ADDENDUM NO. 1

Smathers Beach Restrooms – West ITB 19-018

Smathers Beach Bathroom West

Response to RFI #1.

TITLE: Foundation Plan

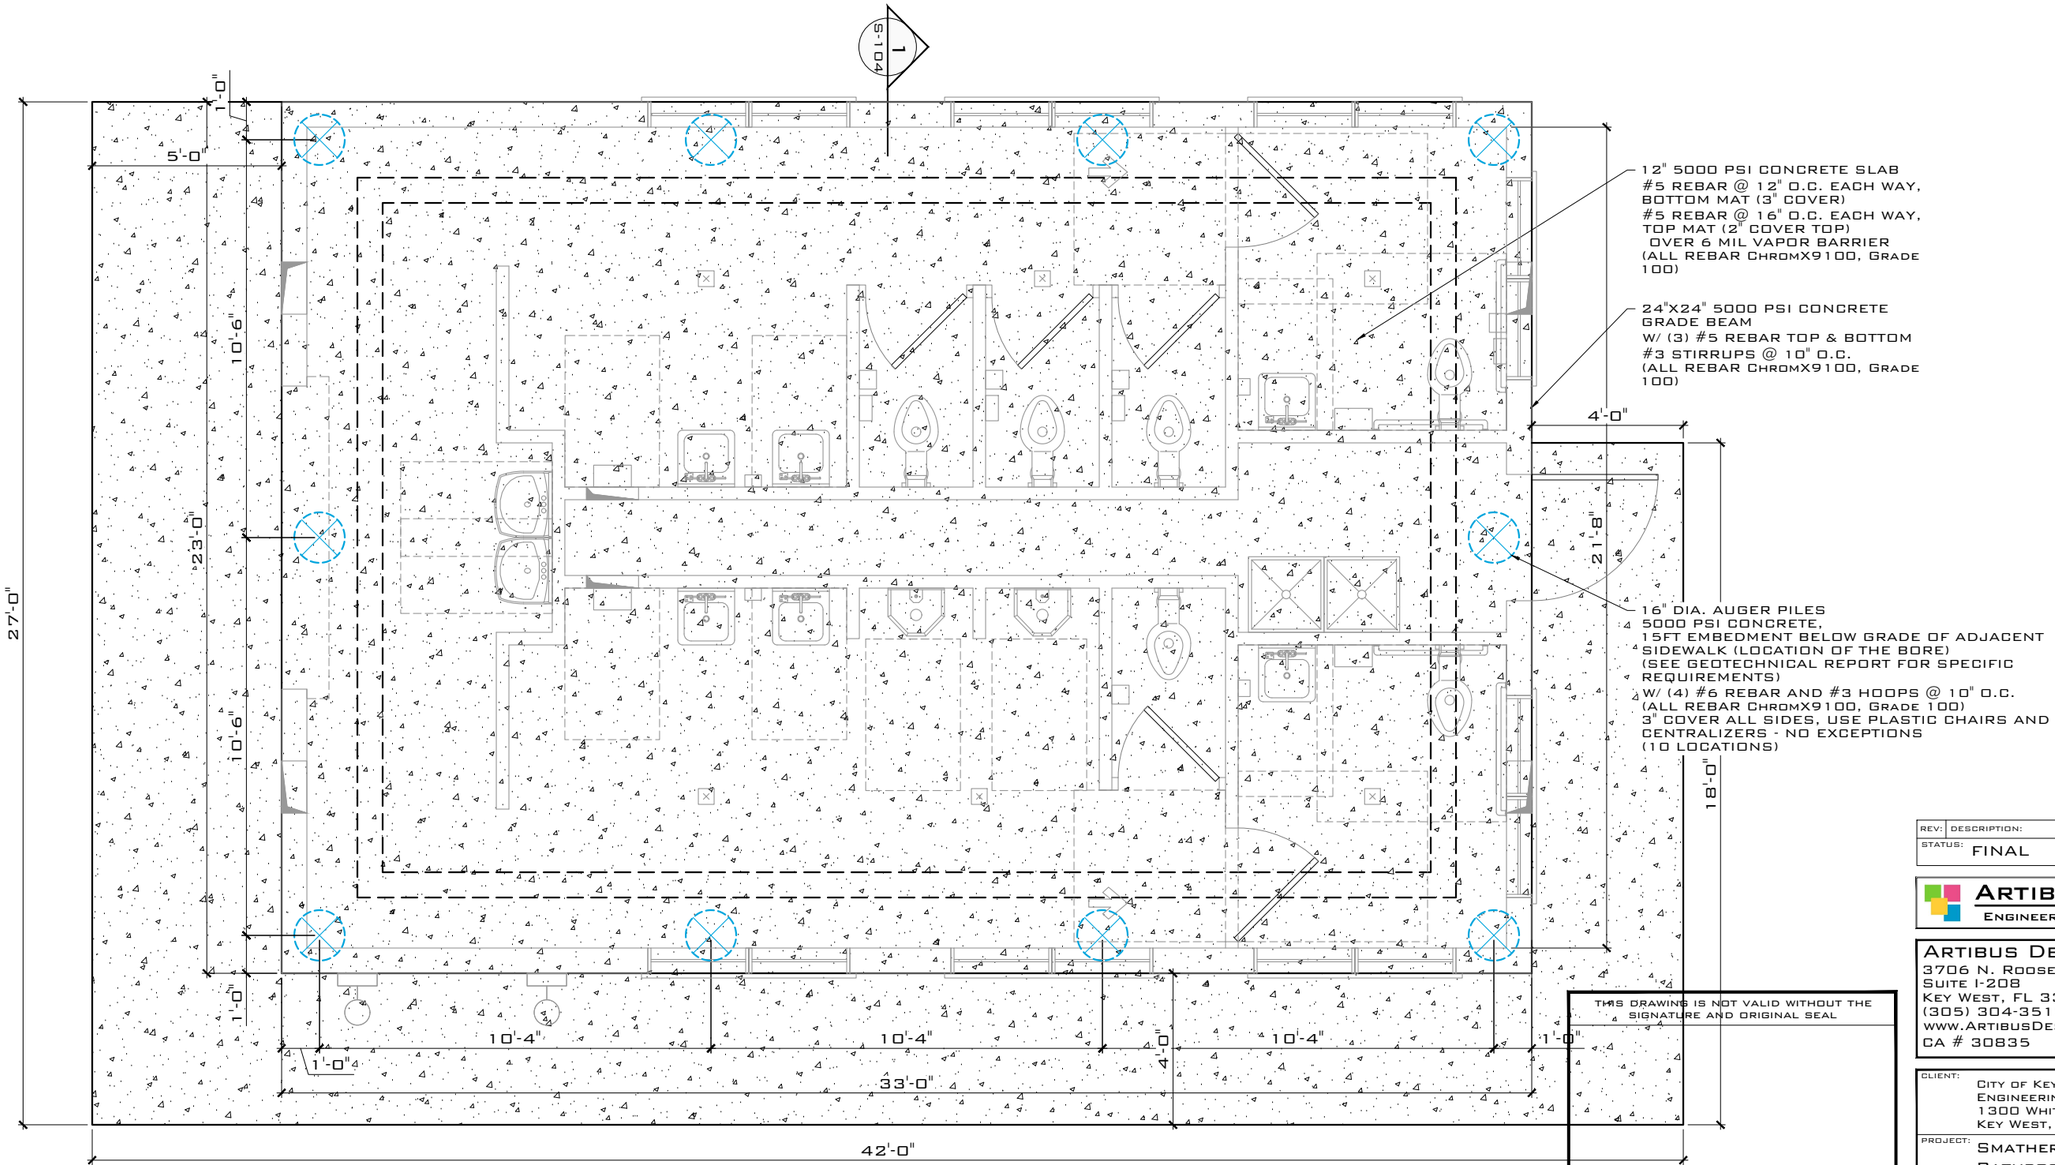
6. Sheet S-101 reads "16" diameter Auger Piles..., 15' Embedment Below Grade of Adjacent Sidewalk (Location of the Bore)". Please clarify the exact location of this boring. Is this sidewalk location on the right of way or is this the sidewalk within the Beach Area?

7. Sheet S-101 shows a 4'-0" wide Concrete Sidewalk along the East and South Sides. The 5'-0" wide Sidewalk along the West runs to the Northwest Corner. Sheet C-102 shows a 5'-0" wide Sidewalk along the South. Additionally, the West Sidewalk terminates at the Break-Away Sidewalk (not at the Northwest Corner). Please clarify.

Response: Please use grade of the sidewalk located in public right of way along S Roosevelt Blvd.

Response: South and west sidewalks adjacent to the building shall be 5.0' and east sidewalk leading to maintenance access door shall be 4.0' wide. Site plan layout C-102 shall be used for site layout.

SECTION 1-1

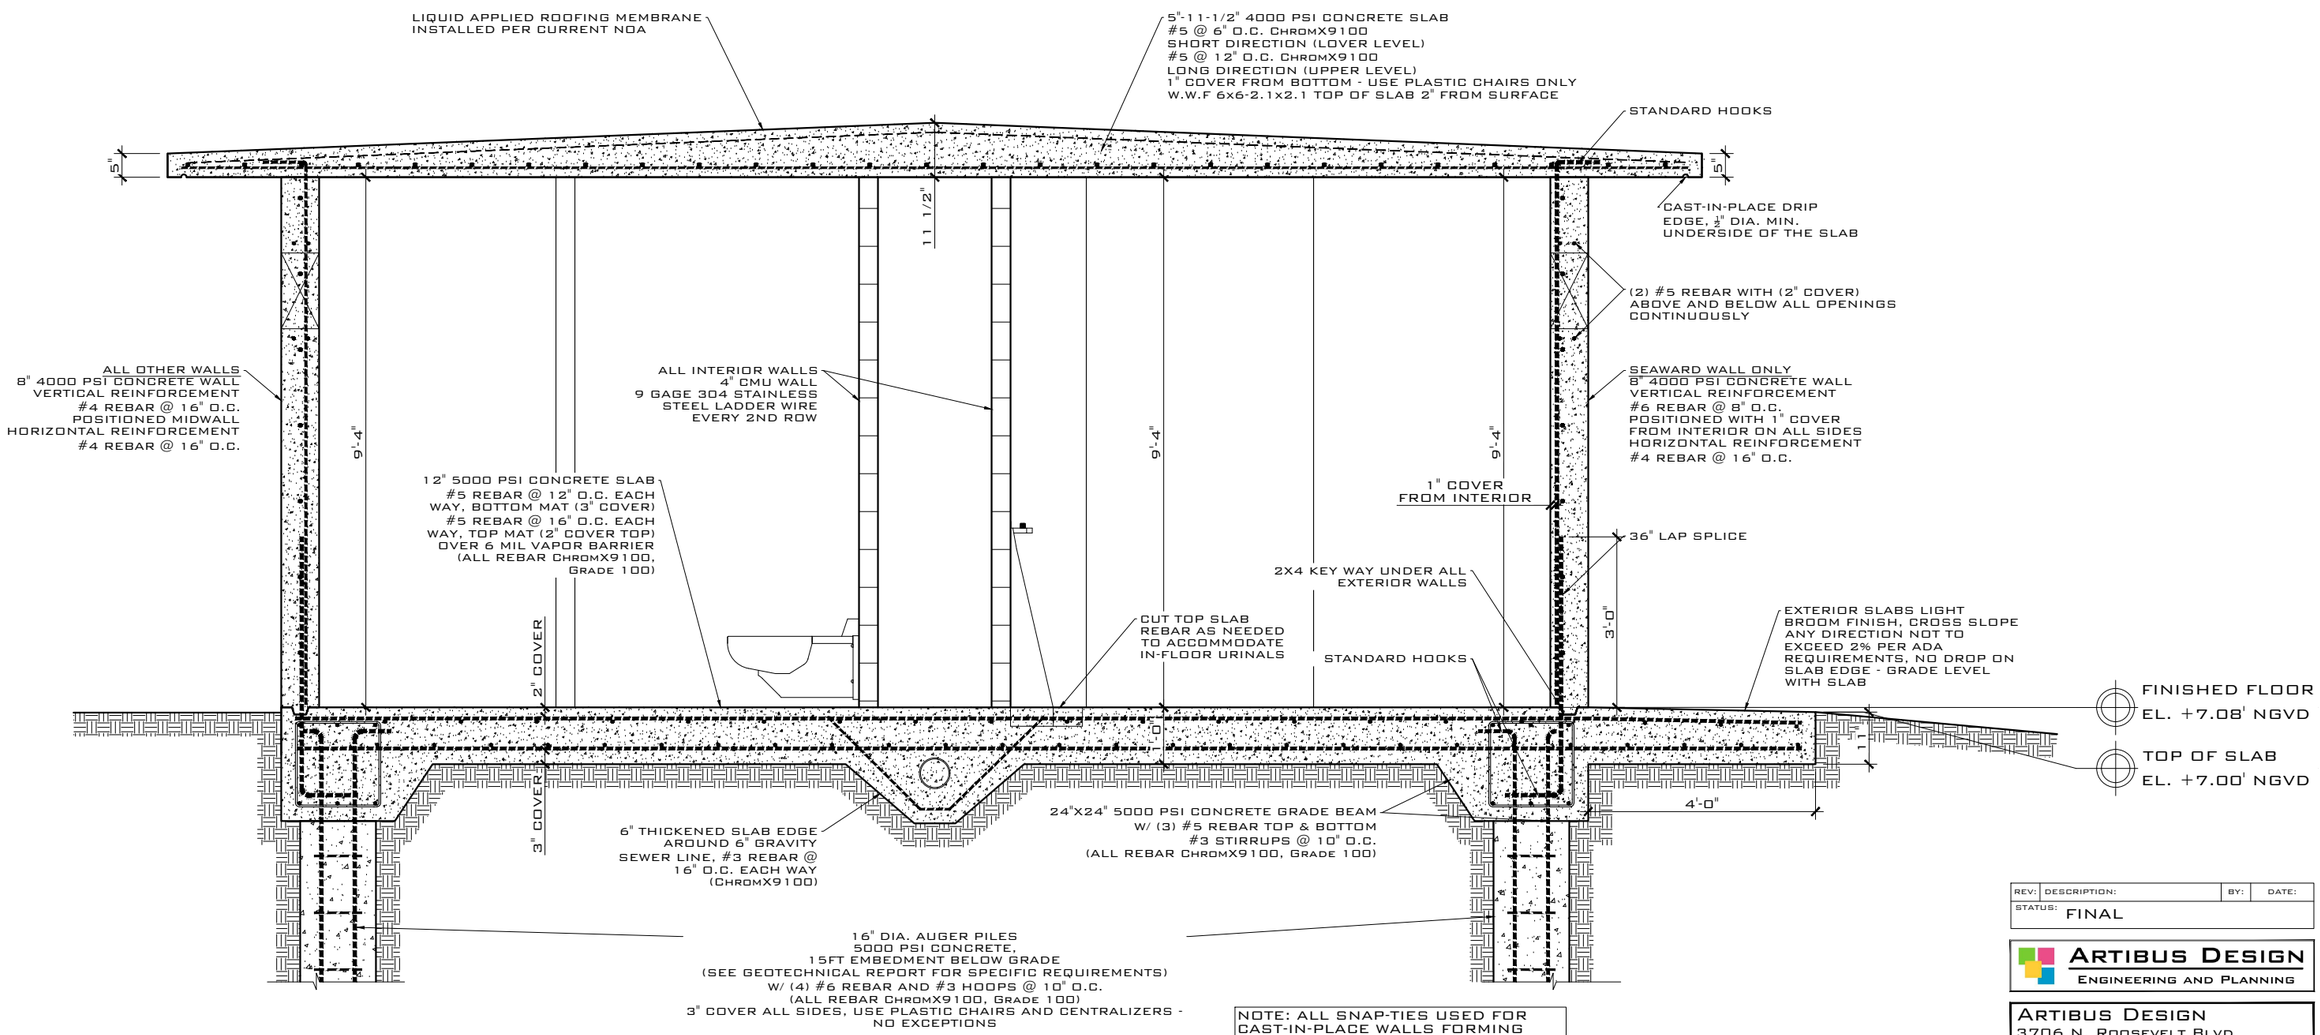
8. Sheet S-104 shows a "2x4 Key Way Under All Exterior Walls". Will an Embedded Water Stop be Required? If so, please specify.

Response: Water Stop is not required.

PROPOSED ELECTRICAL PLAN

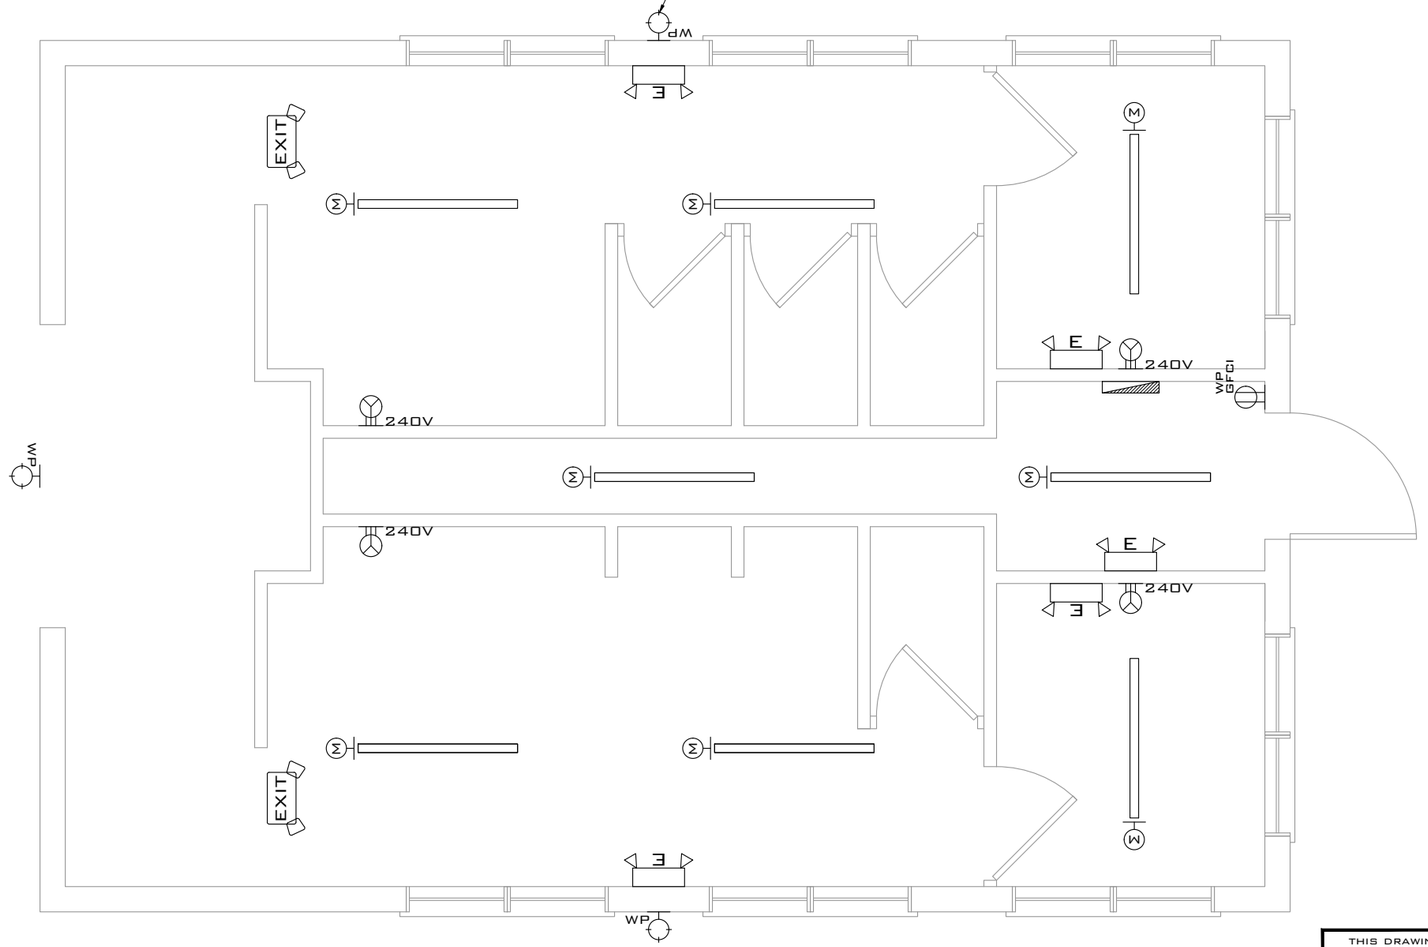
9. Sheet E-101 reads "All Electrcial Components Shall be Located 12" Above Base Flood Elevation" (EL + 12.0 NGVD). However, Sheet A-104 shows the maximum distance above Finished Floor is 46". Finished Floor is +7.08 + 46" = EL +10.91. Please clarify.

Response: Hand dryers shall be considered sacrificial equipment and located as indicated on the plans and per current ADA requirements. All other equipment shall be located 12" above base flood elevation.
